STAFF REPORT

SPECIAL EXCEPTION APPLICATION SE 2009-MV-010

APPLICANT: Wachovia Bank

PROPOSAL: The applicant seeks a special exception to permit an existing drive-in financial institution in a Highway Corridor Overlay (HC) District in order to construct a canopy over a remote teller unit.

Showing a Parcel of Land Identified as Tax Map # 109 2 ((01)) 0023 Containing 0.814 acre	
Sheet 1	Vicinity Map, Notes, Scale, Legend
Sheet 2	Plant Schedule, General Notes, Planting Requirements Tabulations, Deciduous Tree Planting Method

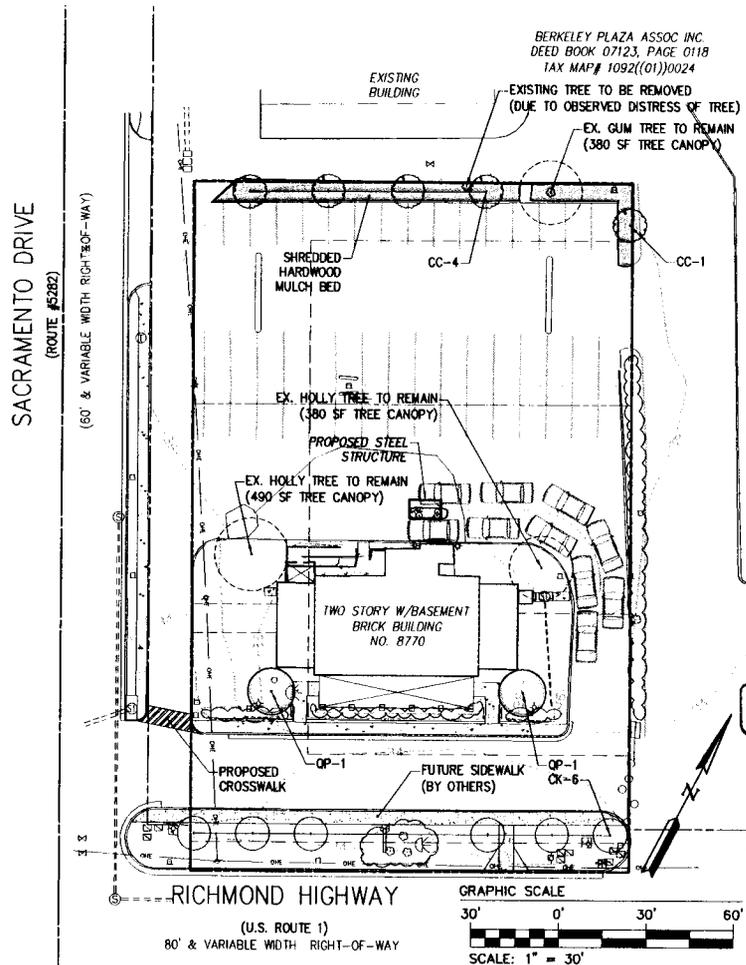
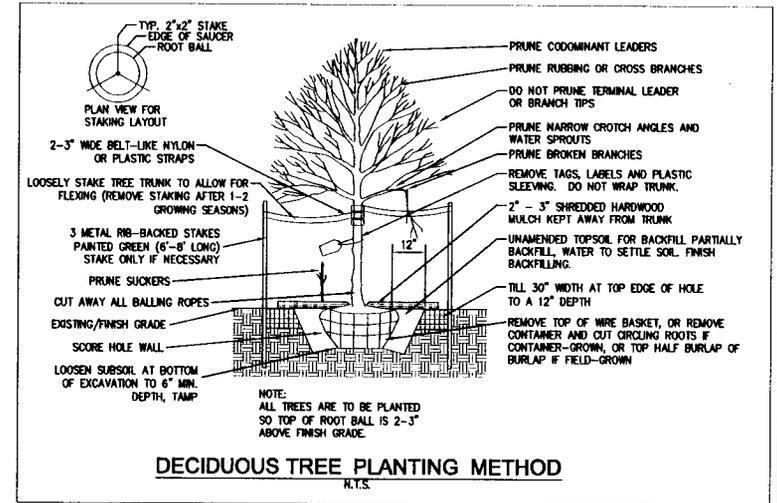
The Comprehensive Plan's urban design recommendations also call for additional landscaped parking islands. Staff has recommended that in order to improve the site's overall condition, the applicant should accommodate the landscaped medians by reducing the amount of parking on-site or by expanding existing landscaped areas within the site. In response to the above recommendations, the applicant has

The applicant has requested permission to have the interior parking lot landscaping requirements waived and the peripheral parking lot landscaping requirements modified to the landscaping shown on Sheet 2 of the SE Plat. As discussed above, the applicant does not wish to provide any interior parking lot landscaping in landscaped medians because parking spaces would have to be removed to accommodate the landscape medians. These parking spaces are needed to provide parking not only for the bank's clients but also for the patrons of the adjacent Mexican restaurant in the Woodlawn Shopping Center that faces the bank's parking lot. As a result, no interior parking lot landscaping is shown on the SE Plat as requested by staff. The applicant also requested permission to have the peripheral parking lot landscaping modified for the same reasons as stated above to the landscaping shown on the SE Plat. The eastern property line already has existing shrubbery, and the applicant has proposed to provide some additional landscaping in a planting strip at the rear of the site and in a landscaped island at the front of the site. As such, staff is satisfied that the applicant's proposed landscaping is sufficient.

UFM staff also notes that the tree canopy calculations and the request to deviate from the tree preservation target requirements need to be addressed and or revised. The applicant has requested a modification of the 10-year tree canopy requirement and a deviation from the tree preservation target requirement due to the reasons stated above. Staff advised the applicant to explore ways to provide additional landscaping to meet the 10% tree cover requirement. In response to staff's request, the applicant proposed to provide additional landscaping in the planting strip at the rear of the site. However, it was determined that the existing tree and the proposed trees would not survive due to the lack of space and resources for the trees to flourish and grow. As a result, staff does not object to the requested modification of the 10-year tree canopy requirements and deviation of the tree preservation requirements.

agreed to plant additional landscaping within the existing landscaped areas within the site. Specifically, the applicant is proposing to plant five (5) trees in the median at the rear of the site, two (2) trees alongside the building, and six (6) trees in the island at the front of the site.
